MODEL 1750B DUAL TRACE AMPLIFIER  
Serials Below 435-00176

Improved B Trigger Out  
Parts Kit 01750-69501

Improved B Trigger Out

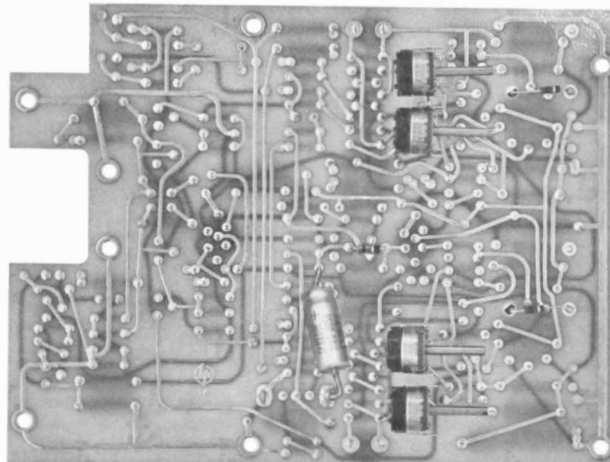
The following modification improves the dc stability of the B Trigger Out Amplifier. Over a period of time dc drift can cause the amplifier to go into saturation.

The bandwidth of the Trigger Amplifier after this modification is 5 cps to 2.5 Mc. Formerly it was dc to 2.5 Mc.

- a. Replace R62 (390K) with 1 megohm resistor.
- b. Replace R63 (33 ohms) with 27 ohm resistor.
- c. Replace R64 (300 ohms) with 150 ohm resistor.
- d. Remove CR51 (diode) and install R60 (7.5K ohm resistor).
- e. Connect a 511 ohm resistor (R59) between the base of Q11 and Pin 8 of V1 (cathode). See Figure 1.
- f. Connect a 50  $\mu$ f capacitor (C55) between the base of Q11 and ground. See Figure 1.
- g. Make the dc level adjustment (R65) as indicated in Section V of your hp Model 1750B Operating and Service Manual.
- h. Change the Schematic Diagram and Replaceable Parts List in your hp Model 1750B Operating and Service Manual to incorporate the above changes.
